Explanation of Significant Difference for the Revision 1 Record of Decision Remedial Alternative Selection for the Wetland Area at Dunbarton Bay in Support of Steel Creek Integrator Operable Unit (U)

SRNS-RP-2022-00982

Revision ~~0~~-1 REDLINE

Figure 2. WADB Project Area (Showing Previous Land Use Control Boundary)

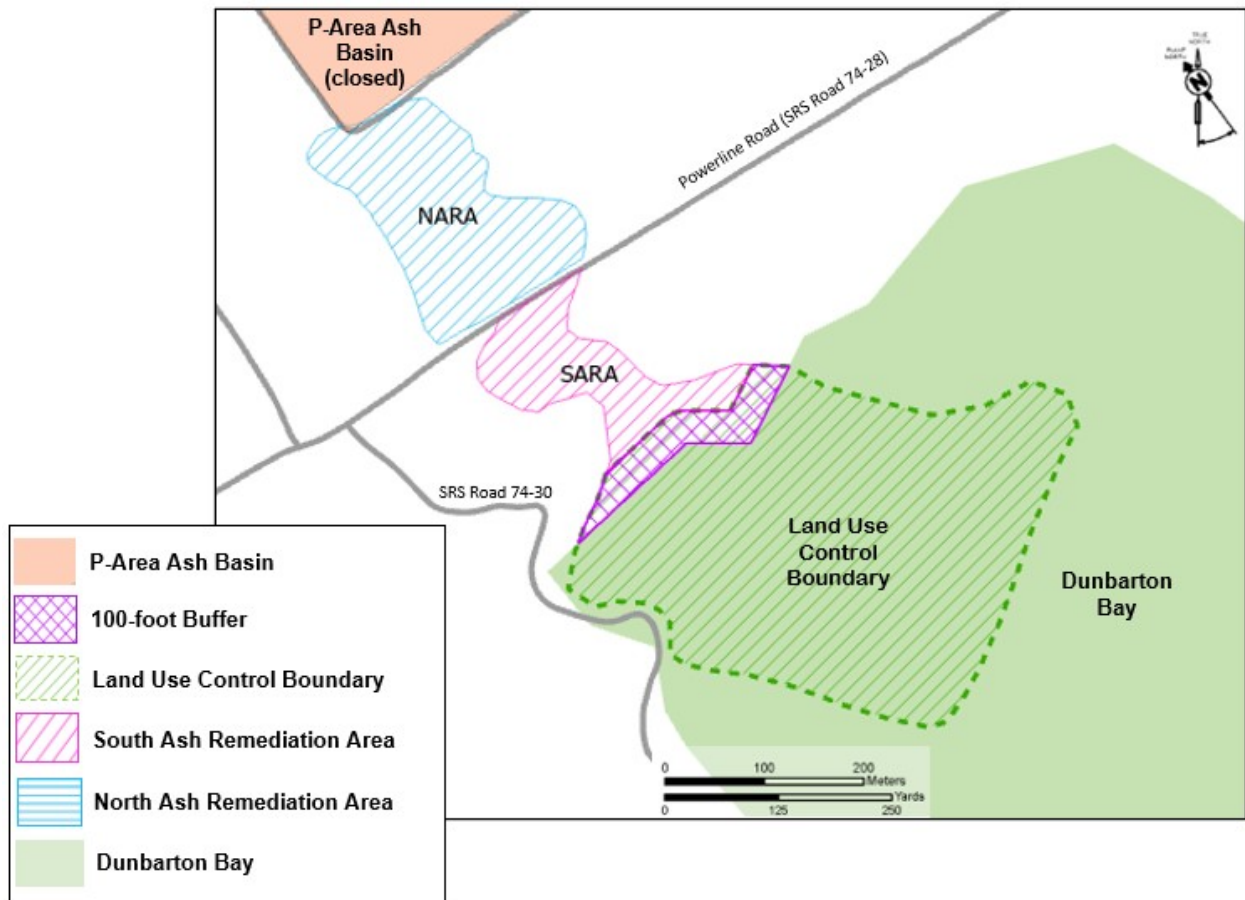
The ROD for the WADB (SRNS 2018a) employed LUCs for 10 ha (25 ac) since the entire volume of waste was not to be excavated and some material would be left in place. The initial LUC boundary is shown in Figure 2. The purpose of this ESD is to document expanded LUCs that include the SARA, the additional ash discovered outside of the SARA, as well as the initial LUC boundary protective of and within the Dunbarton Bay.

Figure 3. Location of Additional Ash, Existing Sign Locations, and Existing Land Use Control Boundary

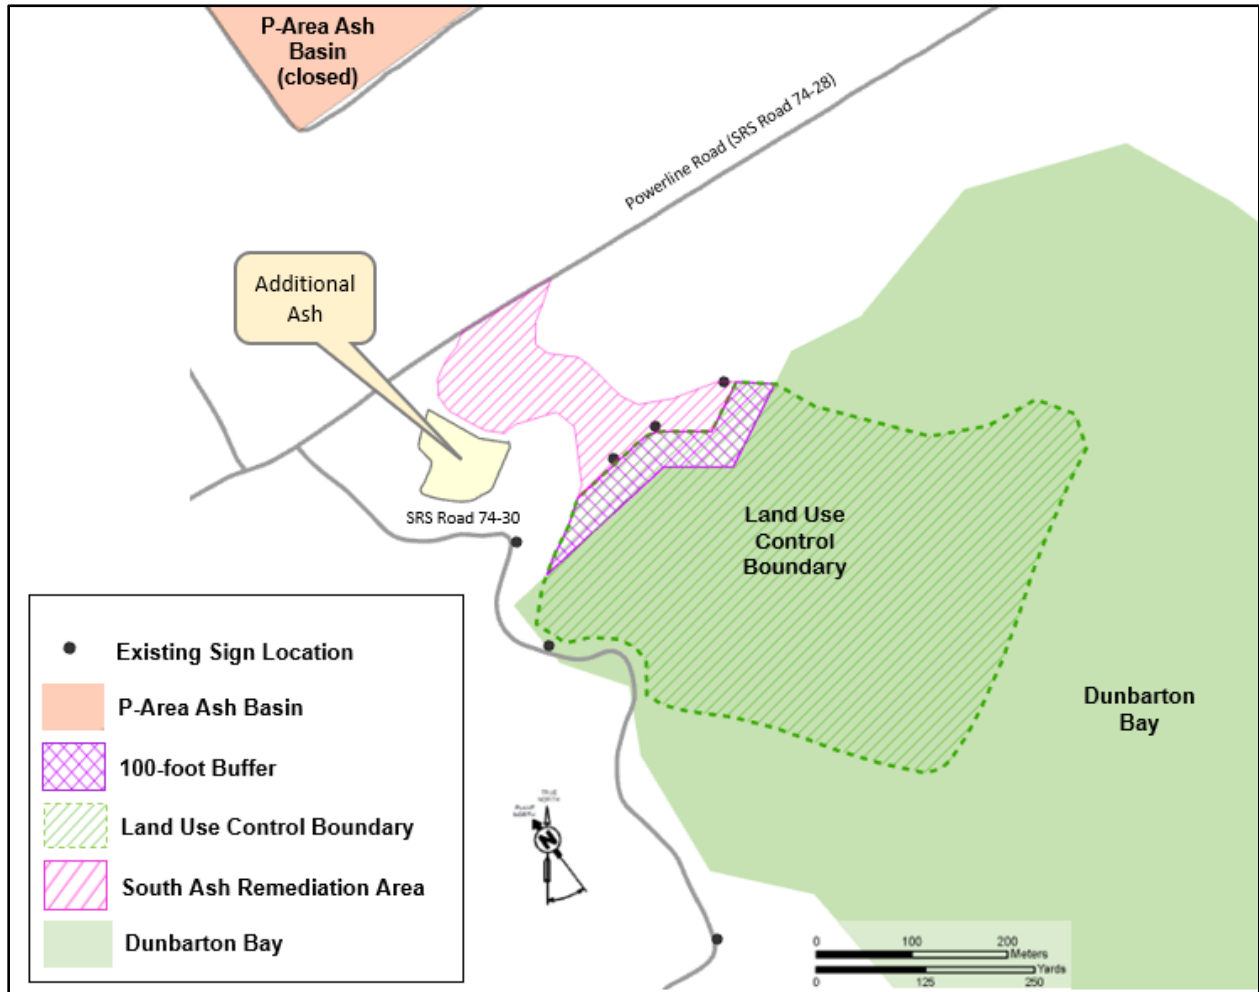
The ROD for the WADB was issued June 20, 2018 (SRNS 2018a). The significant difference described in this ESD is to expand the LUC boundary to include the SARA and additional ash to the east of the SARA ~~in lieu of excavating and disposing of the ash.~~ Expansion of the LUC boundary will be protective of human health and the environment without additional excavation and disposal of the ash. The additional ash is located between Powerline Road and Dunbarton Bay (Figure 3).

The actions described herein are documenting an expanded LUC boundary for the WADB from Powerline Road to the 30-m (100-ft) buffer along the northern edge of Dunbarton Bay. The LUC boundary maintains the previously designated LUC area within the 30-m (100-ft) buffer and within Dunbarton Bay (Figure 3). The entirety of the expanded LUC boundary consists of ~16 ha (~39 ac) (Figure 4). The expanded LUCs are estimated to cost approximately \$50,000. It is estimated that pursuing continued excavation and offsite disposal of the SARA and additional ash would cost approximately \$5.8 Million due to the saturated field conditions along with an

Figure 4. Expanded Area Subject to Land Use Controls

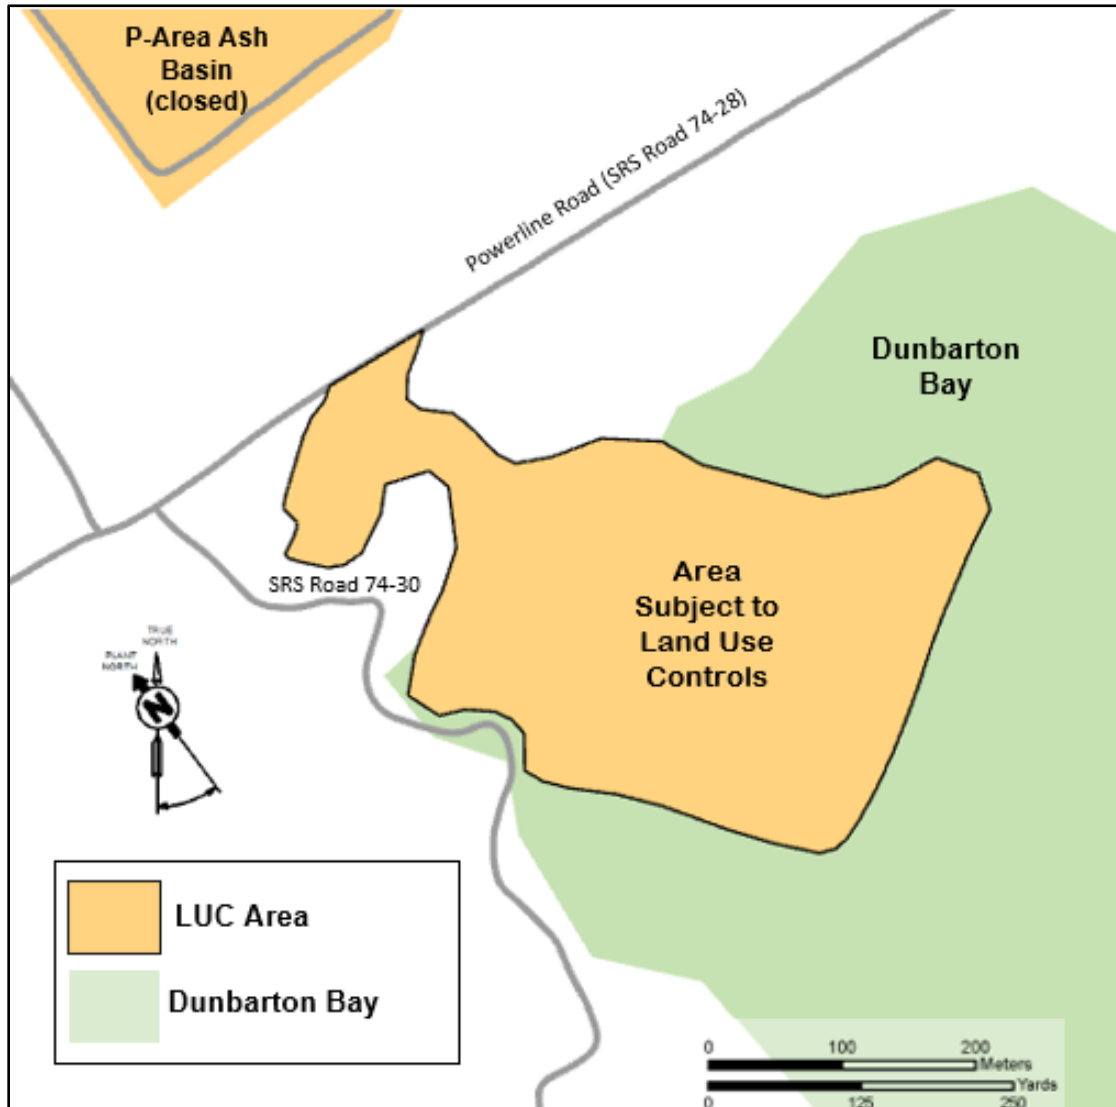
The remedial action addressed in this ESD requires an expanded LUC boundary for the WADB beyond the initial LUC area established for Dunbarton Bay. The expanded LUCs are being implemented to include the ash deposits remaining in the SARA and the

additional ash discovered outside of the boundary of the SARA (Figure 4). LUCs include both institutional controls (i.e., excavation permit restrictions, deed restrictions, health and safety plans for entry, etc.) and physical access controls (i.e., physical barriers, warning signs, no trespassing signs, access controls, and/or fencing, etc.) to minimize the potential for human exposure to contaminants by limiting land access or resource use.

An expanded LUC boundary is required since the remedy leaves hazardous substances in place, beyond the existing LUC boundary, that pose a potential future risk and includes required land use restrictions until the concentrations of hazardous substances in the ash/soil media are at levels suitable for unrestricted use and exposure. Access control warning sign locations will be placed and/or repositioned to include the expanded LUC boundary. The signs are intended to alert onsite workers to the presence of hazardous substances and convey the restrictions of unauthorized personnel.
